From: Burdette, Jennifer a
Sent: Thursday, December 14, 2017 3:50 PM
To: 'Spencer Trichell'
Cc: Richard B Gangle; Higgins, Karen
Subject: ACP

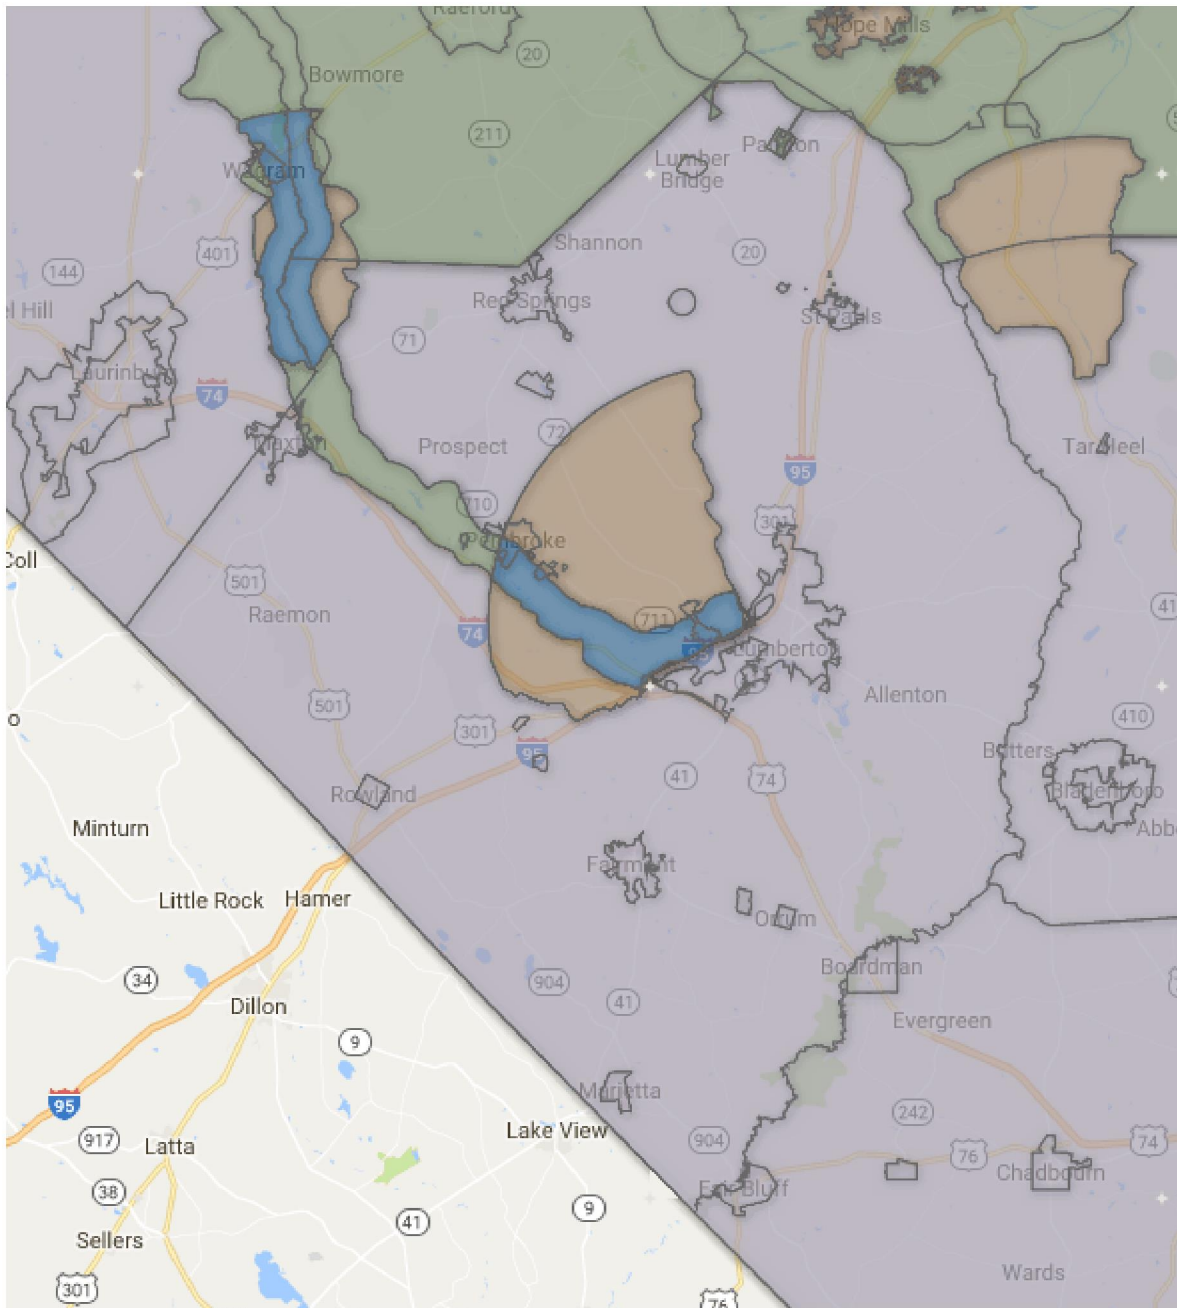
Thank you for your response to our request for additional information received initially by email last Friday. As we discussed, the Indirect and Cumulative Impacts Assessment incorrectly states that Robeson County is subject to the NPDES Phase II Stormwater Rule. Please see an excerpt from the [stormwater program map](#) below. The purple-gray areas do not have a stormwater program.

Because of the lack of stormwater programs in this county, additional information is necessary to determine whether the growth stimulating effects anticipated by the project would be expected to impact water quality. More detailed information regarding the development anticipated is necessary for this determination. Please let us know if you have any questions about this request.
